Newmar Corporation

Technical Service Bulletin							
Date Issued		Model Year(s) Affected		Model(s) Affected		TSB #	
10/19/2006		4/04 – 12/04		All Spartan		271	
Brand						Type	
All	<input checked="" type="checkbox"/>	American Star	<input type="checkbox"/>	Mountain Aire	<input type="checkbox"/>	All	<input type="checkbox"/>
		Dutch Star	<input type="checkbox"/>	Kountry Aire	<input type="checkbox"/>	F W	<input type="checkbox"/>
		Kountry Star	<input type="checkbox"/>	Essex	<input type="checkbox"/>	D P	<input checked="" type="checkbox"/>
Scottsdale	<input type="checkbox"/>	Northern Star	<input type="checkbox"/>	London Aire	<input type="checkbox"/>	D B	<input checked="" type="checkbox"/>
<div style="display: flex; justify-content: space-between;"> <div> <input type="checkbox"/> Air Conditioning & Heating <input type="checkbox"/> Appliances & Accessories <input type="checkbox"/> Cabinets & Furniture <input type="checkbox"/> Chassis Components <input checked="" type="checkbox"/> Construction Components </div> <div> <input type="checkbox"/> Electrical Components <input type="checkbox"/> Exterior Components <input type="checkbox"/> Interior Components <input type="checkbox"/> Plumbing & Ba

Figure #1 - Typical condition after environmental attack, disassembled from vehicle:

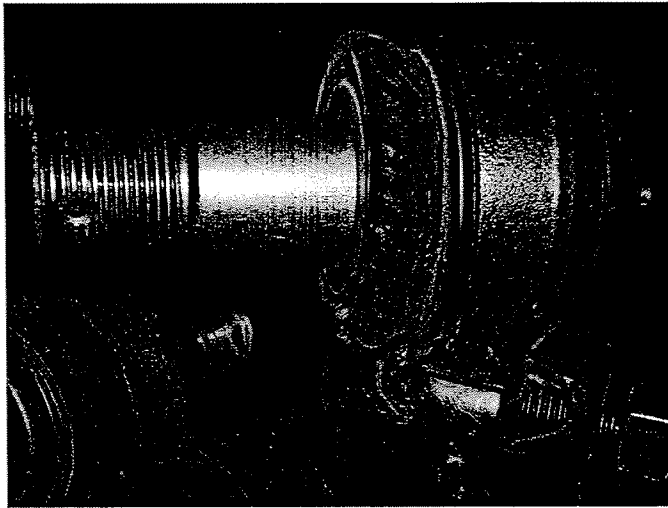
The suggested remedy is to alert the affected customers of the potential condition and to recommend that at the next greasing cycle the tie rod end be inspected for the condition shown in the figures one and two below. If the degradation condition is found, then replacement of the tie rod end only (not the cross tube) should be accomplished. It has been observed that one or both tie rod ends could be affected per vehicle. Also, inspect the tie rod end to ensure it

NOTE: There is a potential for a false diagnosis to occur. Many times the tie rod will receive exposure to primer and / or topcoat paint. This paint will subsequently crack in the field. Cracked paint by itself does not indicate anything wrong with the boot; the issue describe herein is contained in the rubber compound itself. Refer to figures one and two for examples of boot degradation.

Figure #3 – Identification of TRW tie rods (green, pink, yellow or tan color of the nylon ring that is molded into the top of the boot seal varies by part

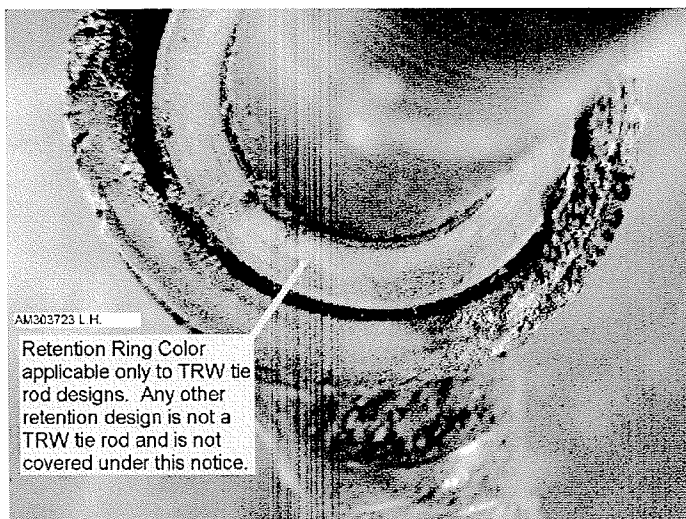
is a TRW component. Please refer to figures 3 and 4 for identification of TRW tie rod end assemblies.
